**James City County Environmental Division  
Stormwater Management/BMP Record Drawing and  
Construction Certification Review Tracking Form**

Project Name: Ironbound Square Revitalization Road Improvement (BMP)

County Plan No.: SP-131-05

Ironbound Square Revitalization Roadway Improvement  
JCC BMP  
County Plan No. SP-131-05  
County BMP ID Code: CC030

TIMBER DRAINAGE STRUCTURE N.T.S. RECORD DRAWING  
 BMP 10 CODE: CC030 COUNTY PLAN # JCC SP-131-05

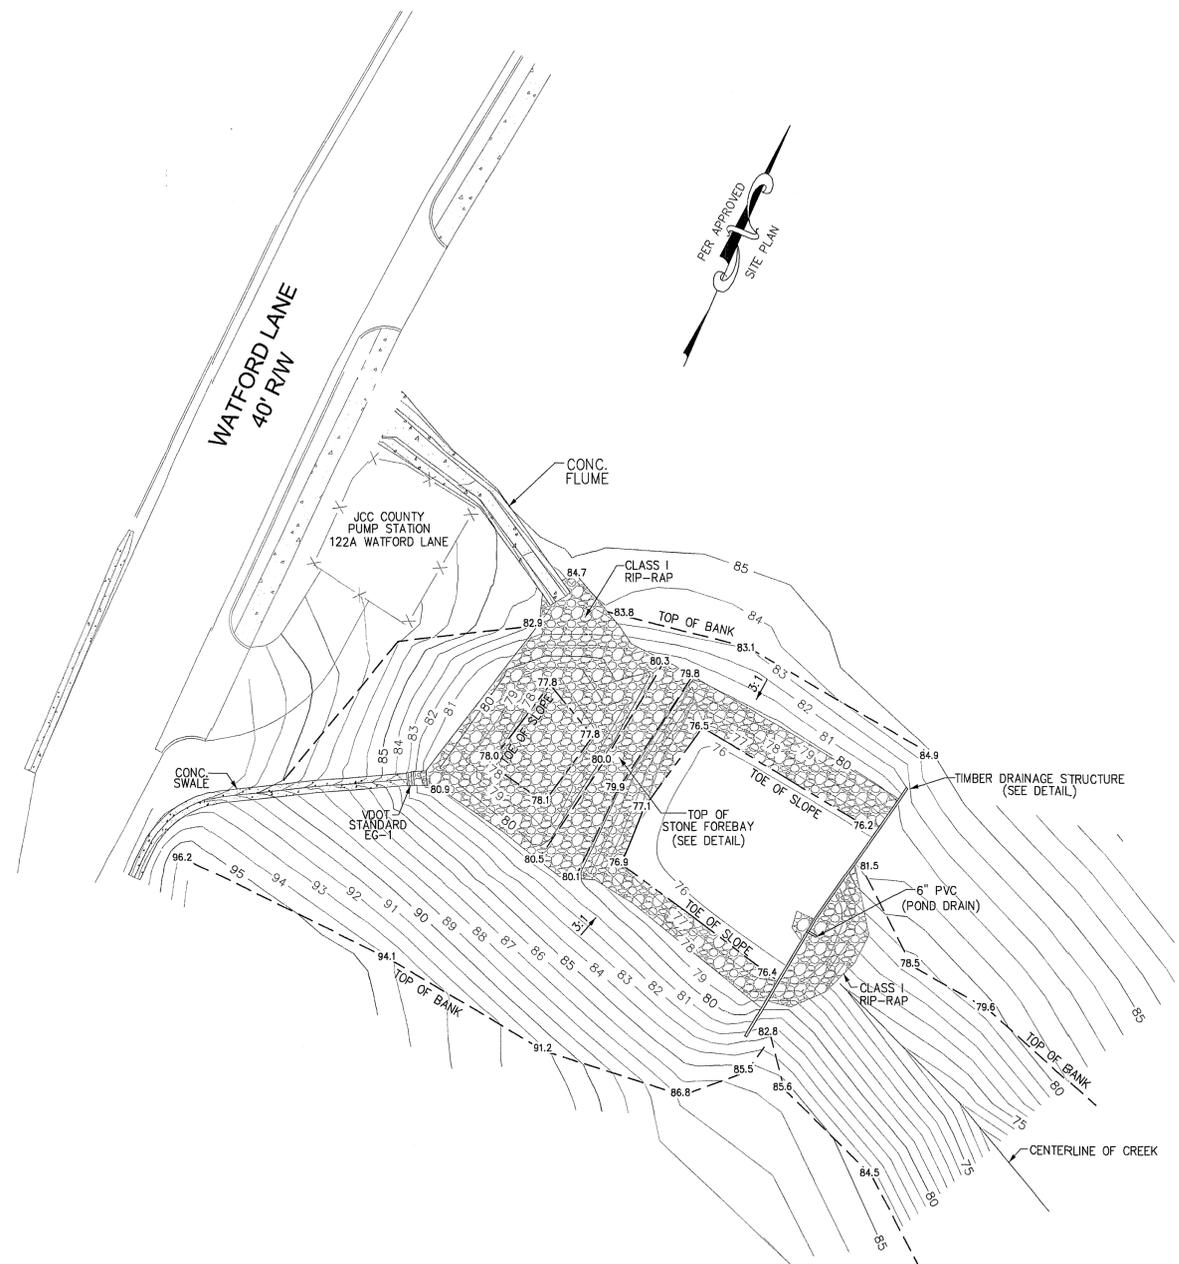
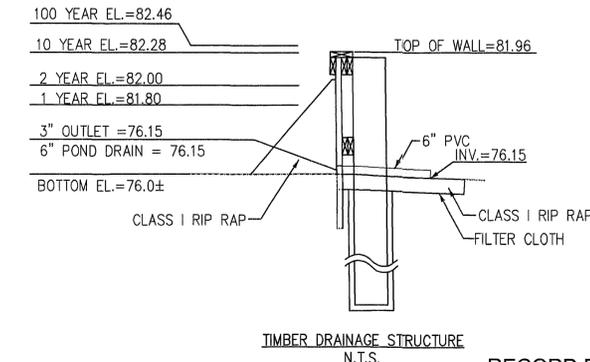
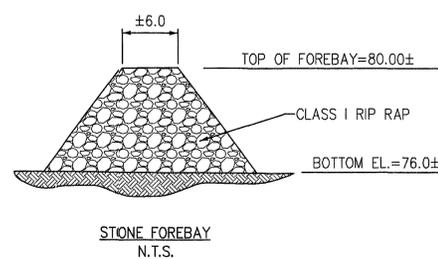
4. **Record Drawing:**
5. The record drawing set dated 7/10/2007 is **unsatisfactory**.
6. On original plan set dated 6/8/2007 rip rap is delineated on site plan as existing rip rap. On the record drawing this was omitted. During the field inspection it was noted that the stone is in place. In addition to this a detail of this area should be on the record drawing as well. ✓ @

7. Show the following additional information on the record drawing: size of stone, area of coverage and any elevation changes. ✓ @
8. Add the following County identifiers to the lower right hand corner of the record drawing: ✓ @

9. County Plan Number SP-131-05 and BMP ID Code: CC 030.

NO.	DATE	REVISION / COMMENT / NOTE
1	1/3/08	REVISIONS PER COMMENT LETTER DATED DECEMBER 19, 2007.

RECORD DRAWING

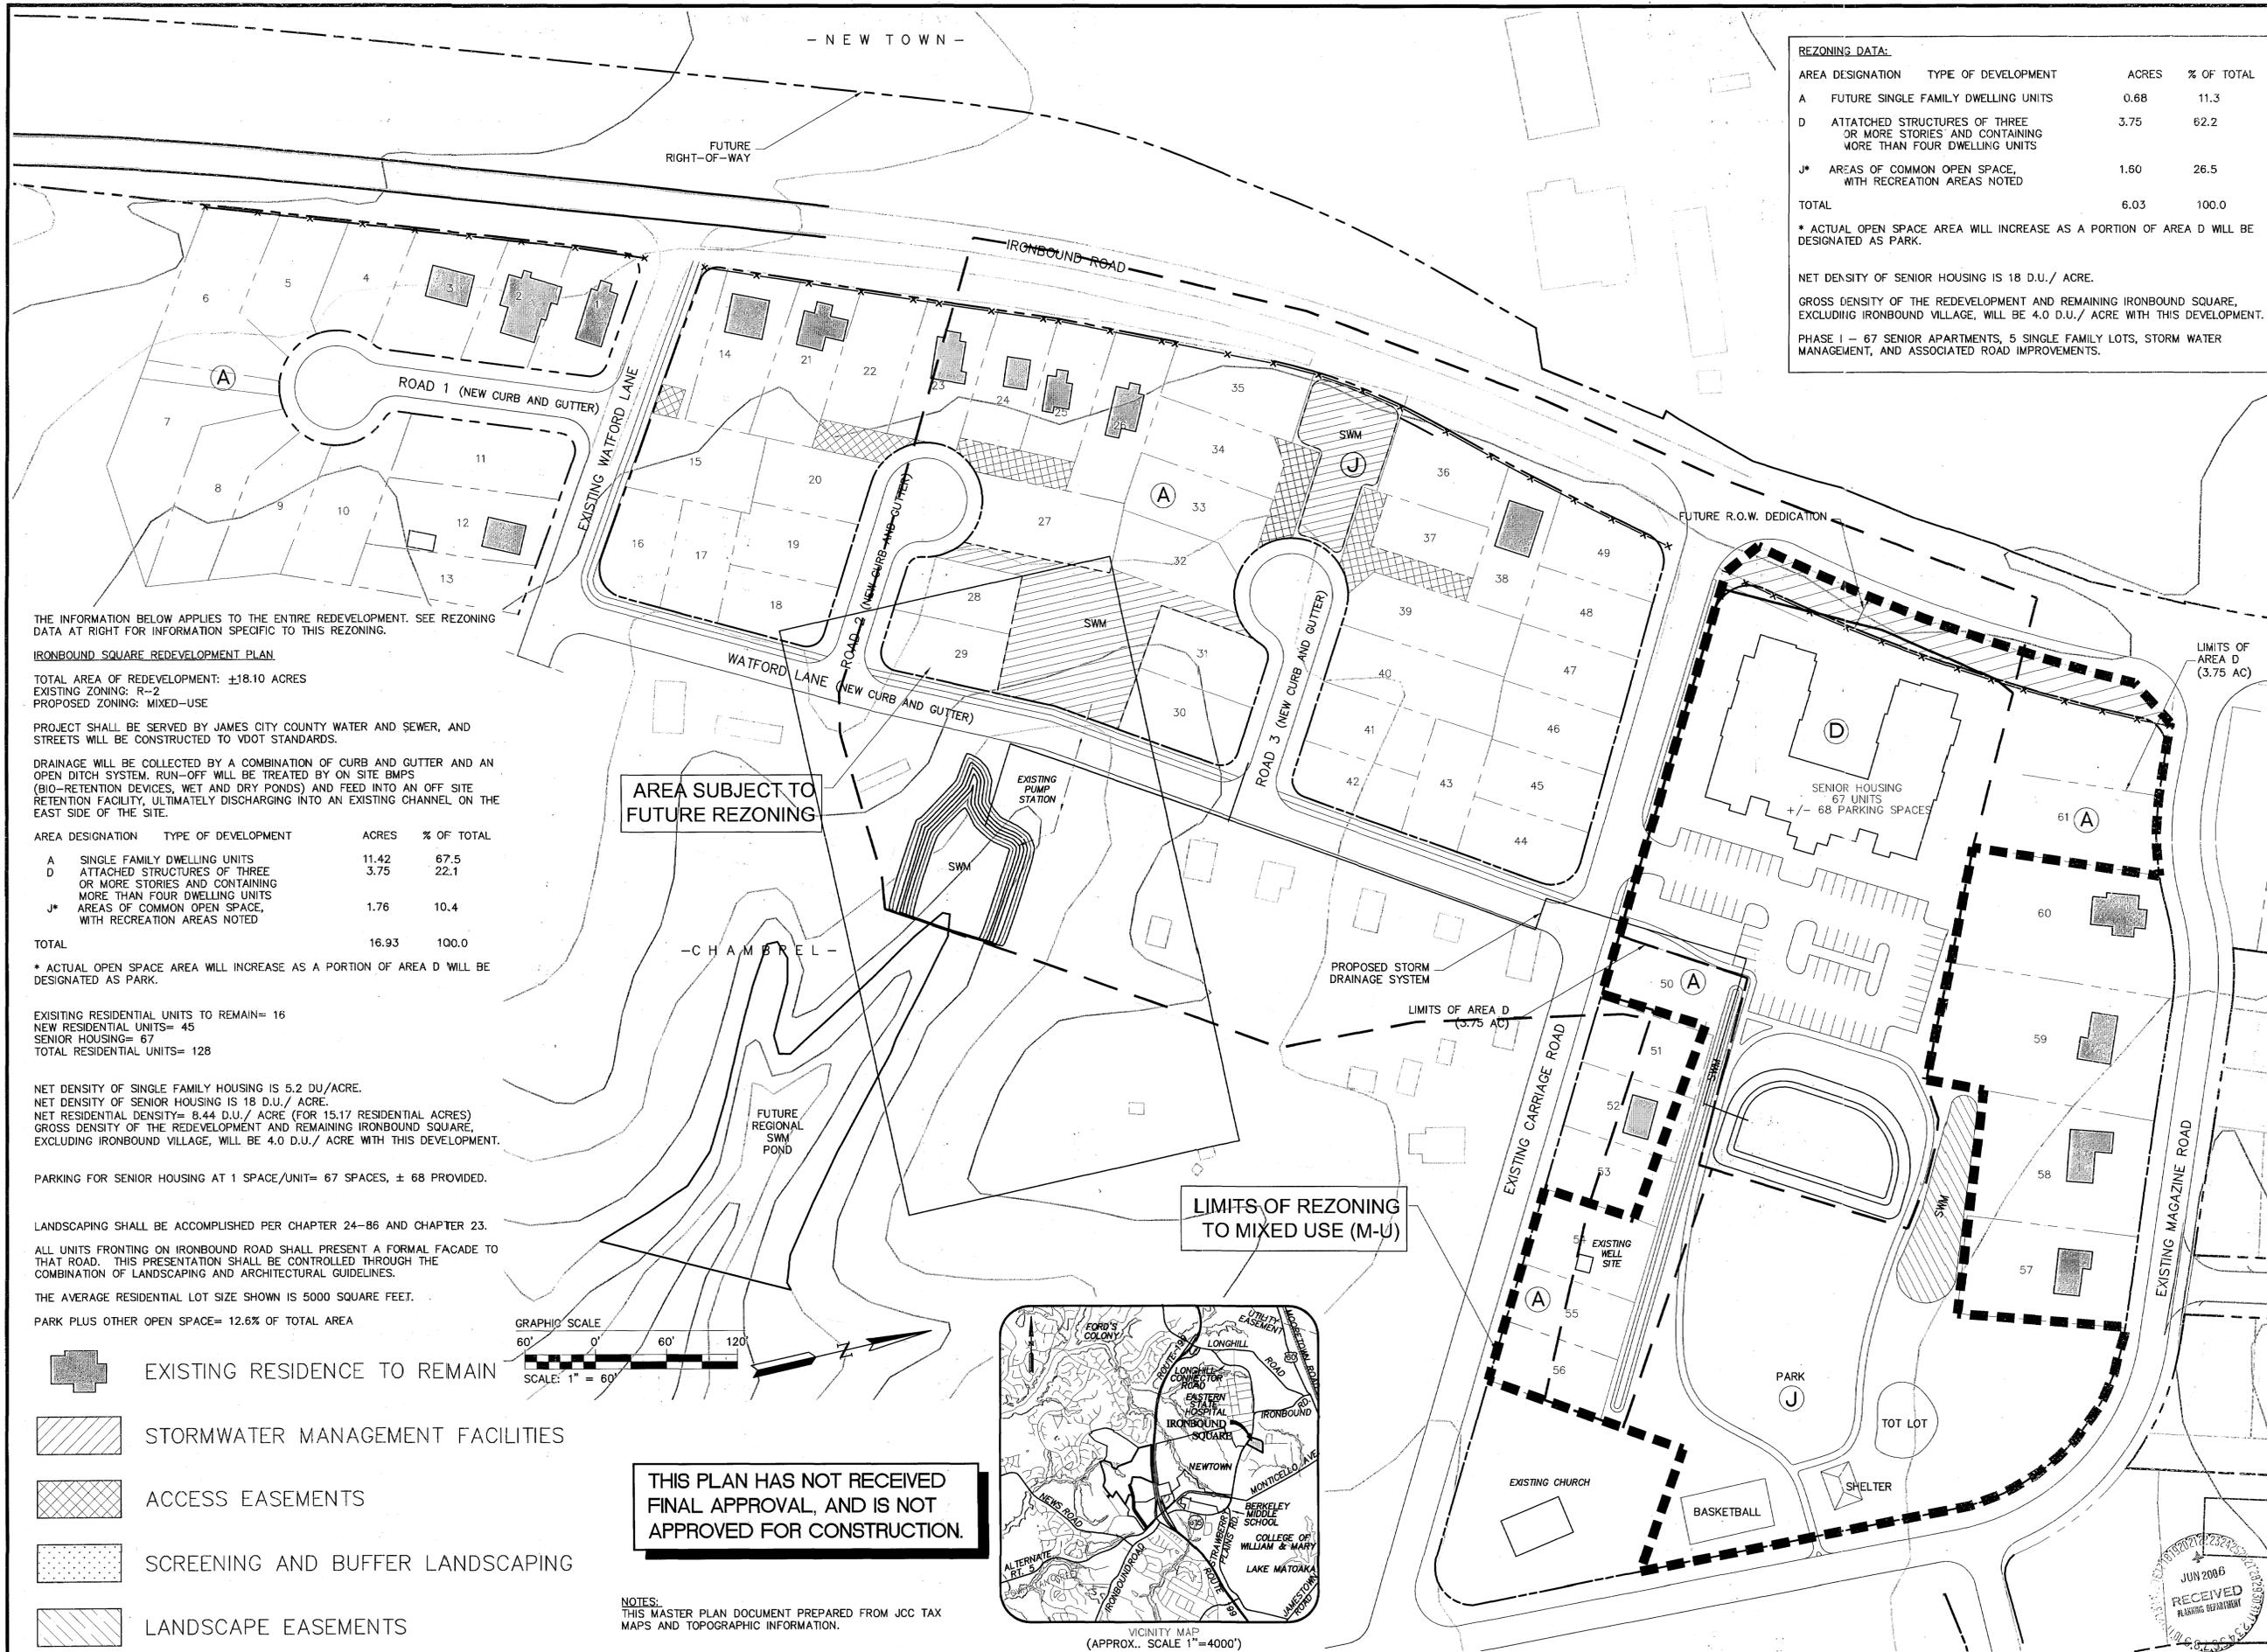
4. **Record Drawing:**
5. The record drawing set dated 7/10/2007 is **unsatisfactory**.
6. On original plan set dated **6/8/2007** rip rap is delineated on site plan as existing rip rap. On the record drawing this was omitted. During the field inspection it was noted that the stone is in place. In addition to this a detail of this area should be on the record drawing as well.

7. Show the following additional information on the record drawing: size of stone, area of coverage and any elevation changes.
8. Add the following County identifiers to the lower right hand corner of the record drawing: County Plan Number SP-131-05 and BMP ID Code: CC 030.
